COMMUNITY DEVELOPMENT DEPARTMENT
80 Columbia Avenue ♦ Marysville, WA 98270
(360) 363-8100 ♦ (360) 651-5099 FAX

Re: Kallcott (Sunnyside Road) PRD – *Pre-Application*
PREA22-002

This letter is intended to summarize the Planning Divisions comments regarding the above referenced proposal. These comments are preliminary in nature and are based on the applicable development standards outlined in the Marysville Municipal Code (MMC). Preliminary comments do not vest an applicant to the existing MMC. Development conditions are based on the most current MMC provisions in effect at the time a *Determination of Completeness* has been issued on a formal land use application.

RE: Kallicott-Sunnyside PRD, File# PREA22-002
Proposed construction of 26-lot single-family Planned Residential Development
4614 87th Ave NE & 8507 E. Sunnyside School Road
Parcel's # 00590700016201 & 00590700016202

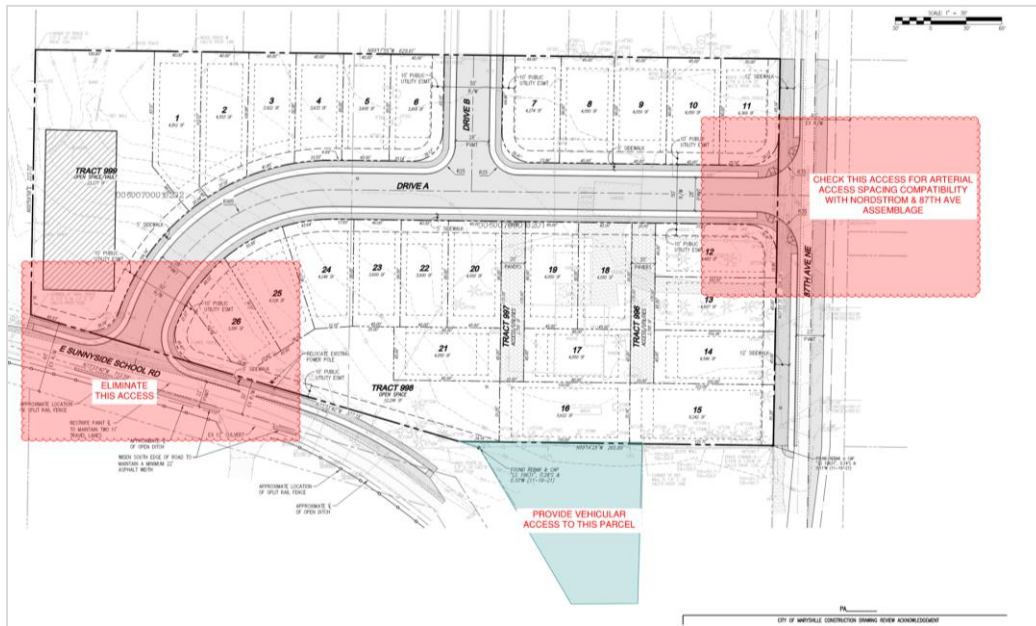
Additionally, the triangular parcel immediately to the south (00590700017503) has inquired about constructing a home. That parcel currently has no access to public ROW except to Sunnyside School Road, I would like this project, Sunnyside PRD, to provide access to that parcel and avoid a future access issues when we close E Sunnyside School Rd. I am willing to approve a variance to extend Tract 997 and serve the parcel to the south, as a shared driveway, if it would work into their design. See the illustration below.
